This after-the-fact COA is being submitted to address the issues discovered during the historic inspection on May 1.

NEW DWELLING FOR:
534 EAST 32nd STREET
SAVANNAH, GEORGIA

Certificate of Appropriateness

File No. 25-002207-COA

EAST ELEVATION
SCALE: 1/4" = 1'-0"

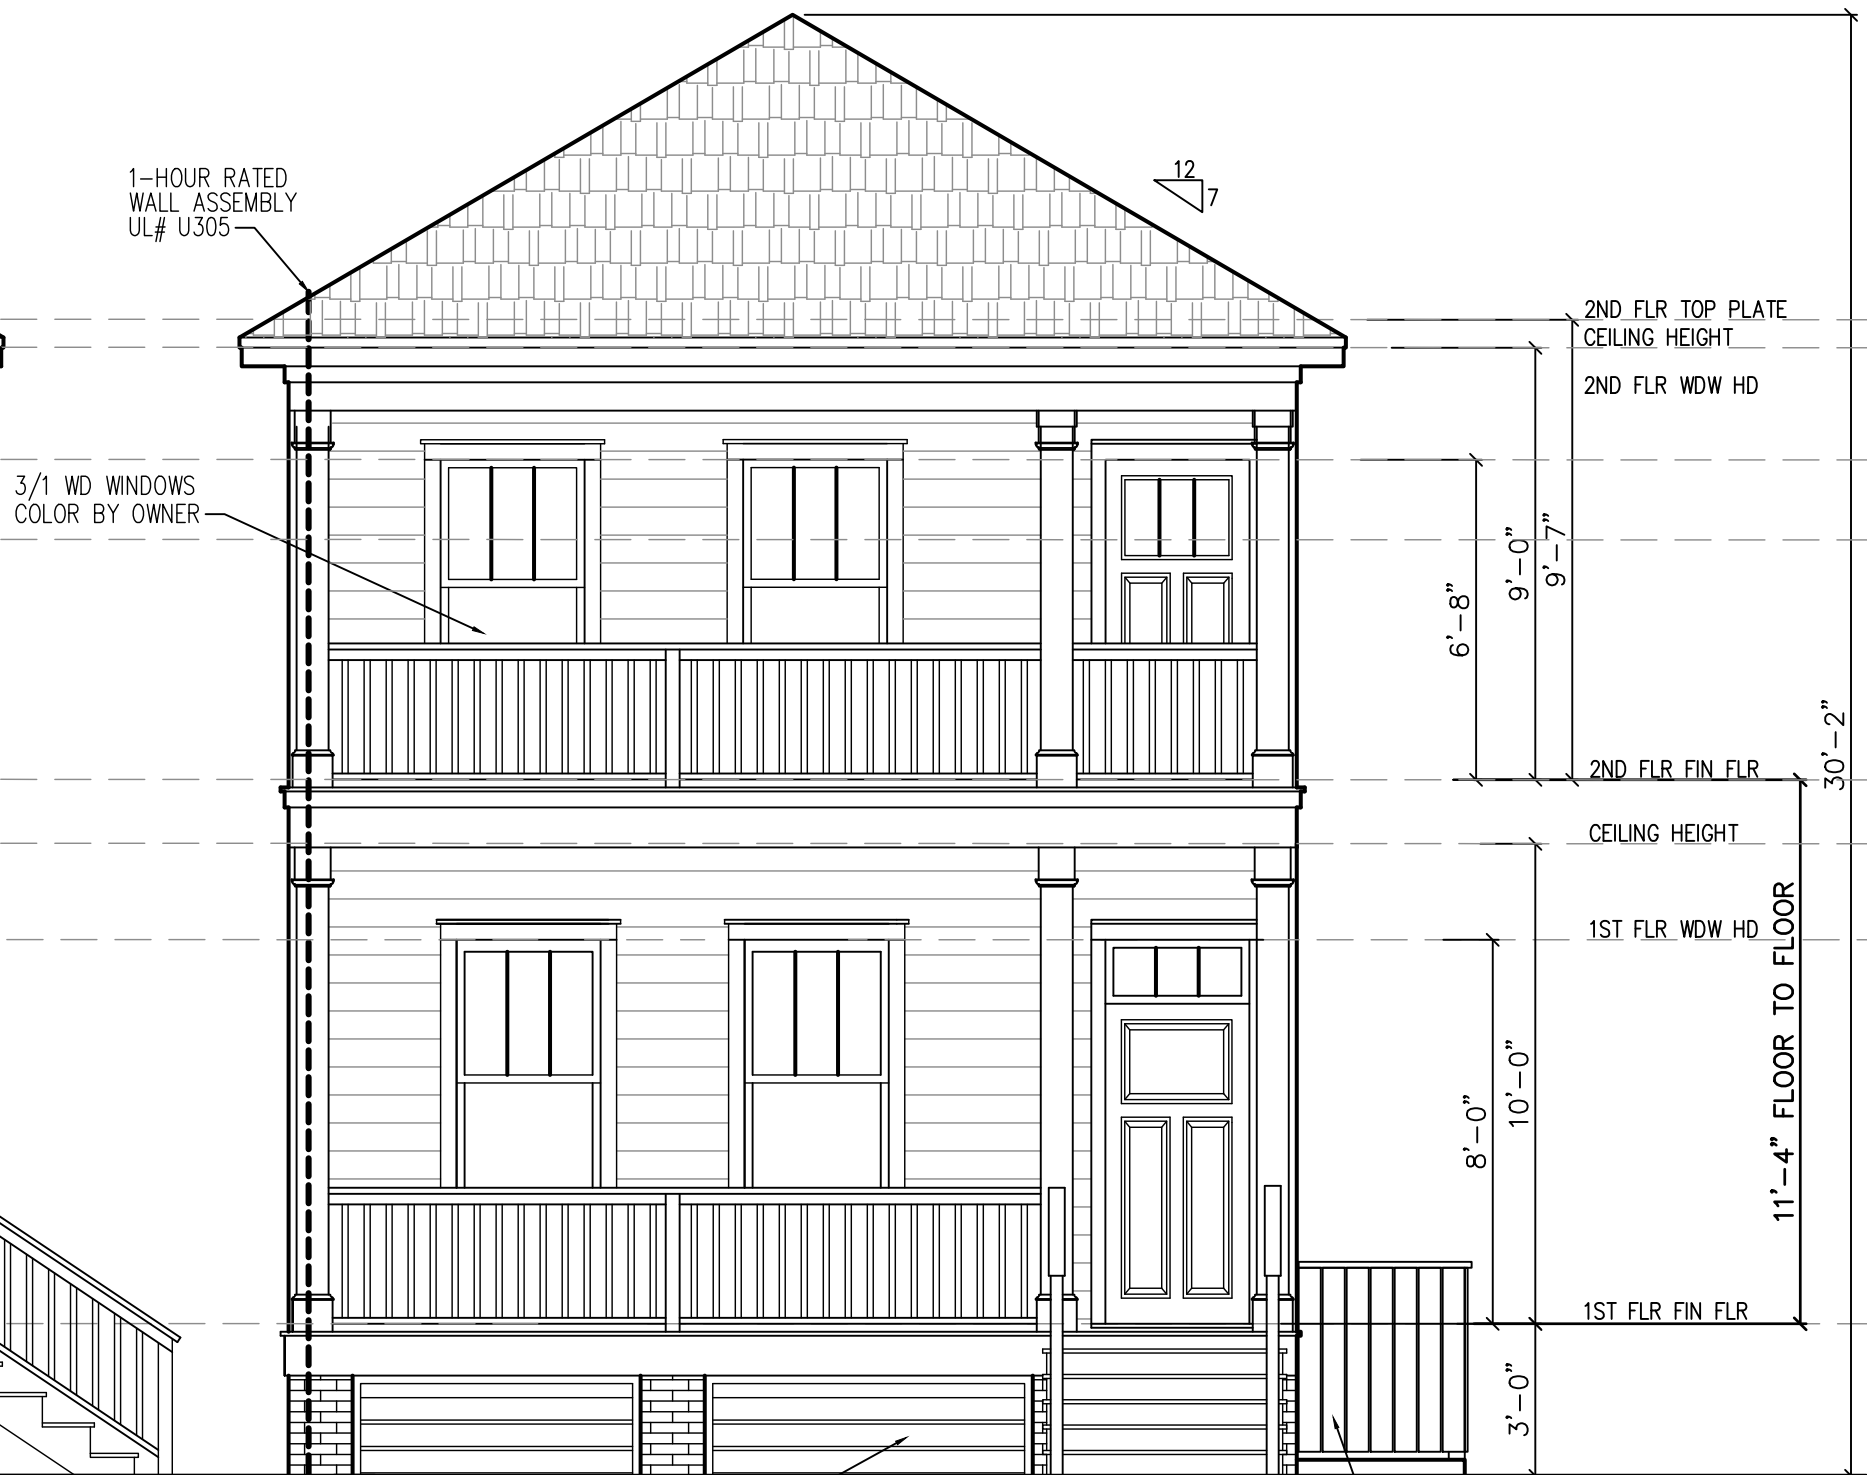
- 2) A small window on the 1st floor on the west facade was enlarged from what was approved. The plans show a 3'0"x2'10" window. The installed window is 2'-4"x4'0". See attached documents.

2) 2'-4" x 4'-0"
